Evo X SST to Manual Conversion without 5MT Wire Harness Install

(SST Gearbox is removed and 5 MT installed, Lever is unplugged)

BACKUP LIGHT <TC-SST>

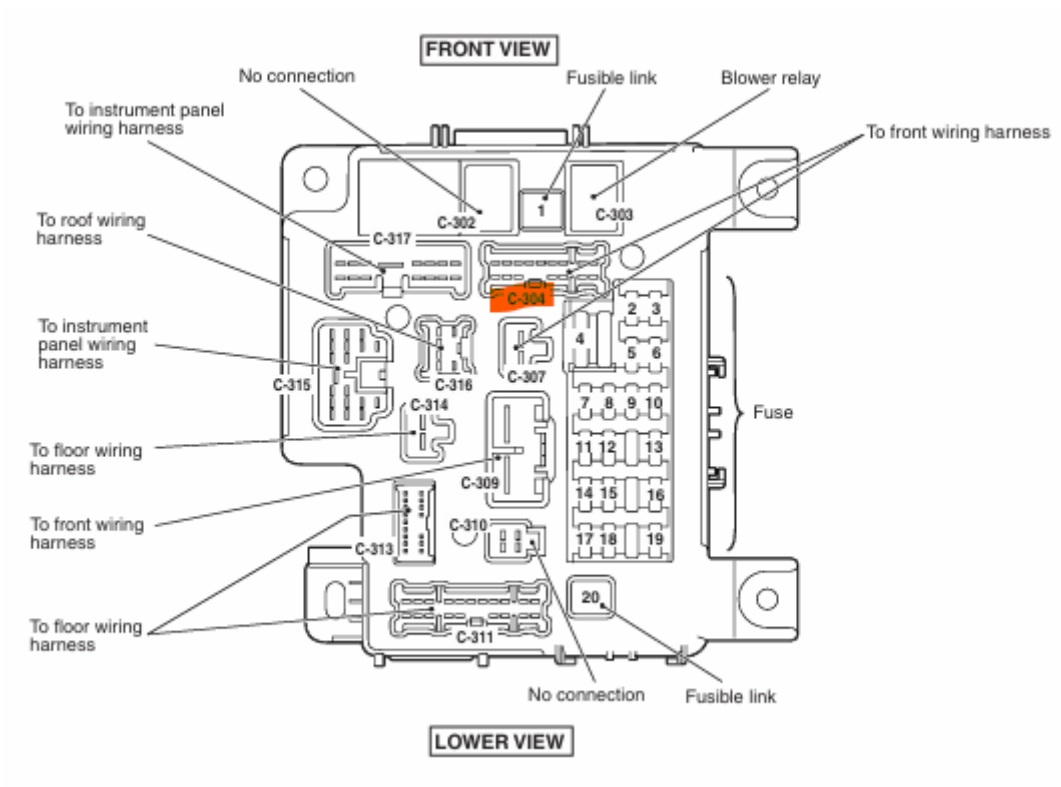
2. Backup Light: Reverse Signal come from Lever Position. The ABS Controller needs this Info.
 Fix: Shift Lever Connector C-27 Connect Pin 4 to Pin 3, Cut Wire from Pin 2 Connector C-304 at ETACS and go over Backup light Switch at the 5MT Gearbox.
